## BOROUGH OF AMBLER COMMITTEE MEETING

August 1, 2023

Preliminary/Final Land Development

Residential Apartment Building - Ambler Lakeview Development, L.P.

Attachment B: Reduced Copy of Applicant's Proposed Site Plan

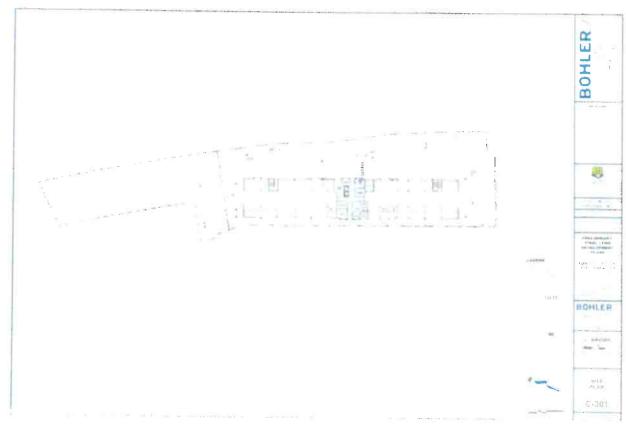
A. <u>Maple Avenue Property Frontages</u>. The plan set indicates that the applicant proposes to add sidewalk along the Maple Avenue frontage of Parcel B, the parcel where the building is proposed. We strongly recommend that the applicant be required to complete the sidewalk along all frontages of both parcels with Maple Avenue.

- 1. a pedestrian pathway (sidewalks plus crosswalks as needed) from the parking lot on Parcel A to the street,
  - 2. a pedestrian pathway (sidewalks plus crosswalks as needed) from the parking lot on Parcel A to the building,

- 3. crosswalks across the driveway entrances to the site, and
  - 4. crosswalks across the driveway entrances to the first floor parking areas in the building.

- A. <u>Parcel and subdivision clarity.</u> The applicant's submitted plan set does not show the entirety of both parcels and is lacking clarity as to whether the two parcels are proposed to be merged into one as part of this proposal. We suggest that the applicant may need to join the parcels in order to comply with zoning in the municipalities. If Parcel A remains as a separate parcel, its principal use will be as a parking lot, which may not be a permitted use in the relevant zoning districts in all three municipalities.
